REQUEST FOR INFORMATION **DATE:** September 16, 2016 **NO.:** RFI-284

Project Name: 15051-Webster University Interdisciplinary Science Building Project No.: 15051

Subject: Pipe routing in ASI#25

1 LEVEL 03 Field-DWV - Area A
1/8" = 1'-0"

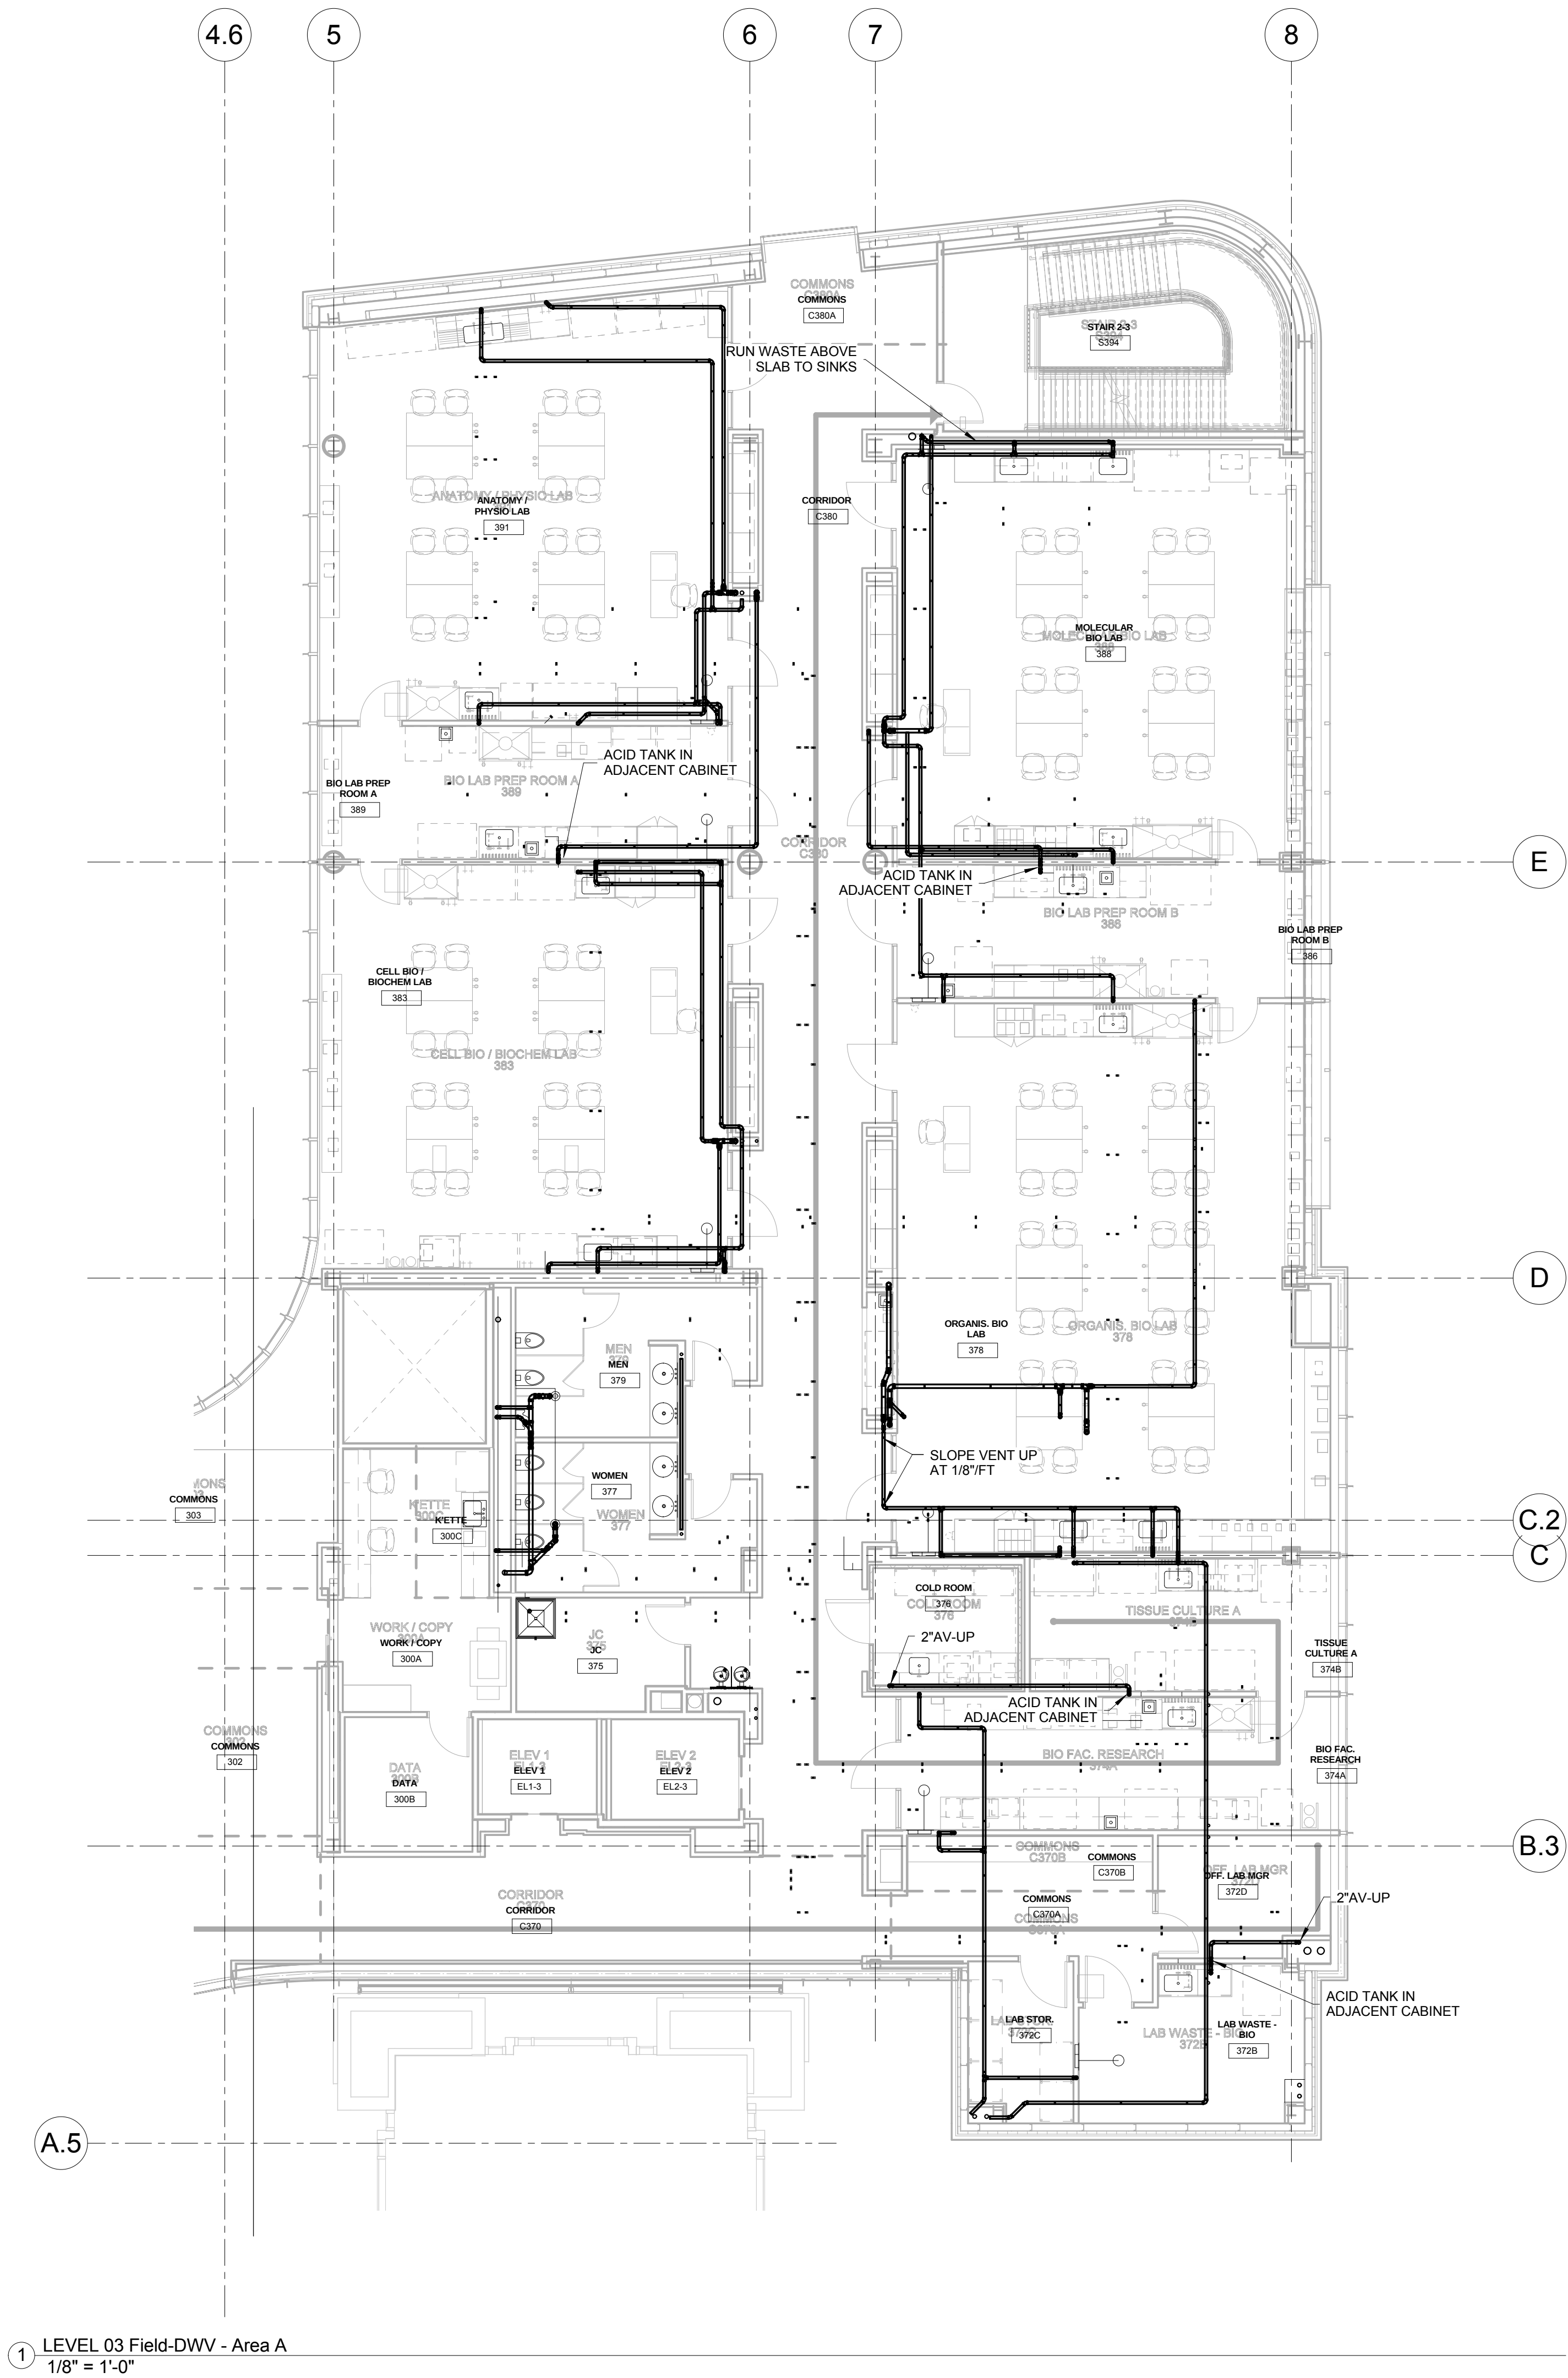
Please advise if the acid vent piping for the 2 sinks in the SE area of Level 03 can be more efficient by going straight up the building with the acid piping in the nearest side wall, instead of going all the way to the far SE corner as indicated in ASI#25 (see attached). ASI#25 routing is more pipe footage (and therefore more expensive).

Acid vent routing proposed by the contractor is acceptable. The contractor does have discretion in routing of piping.
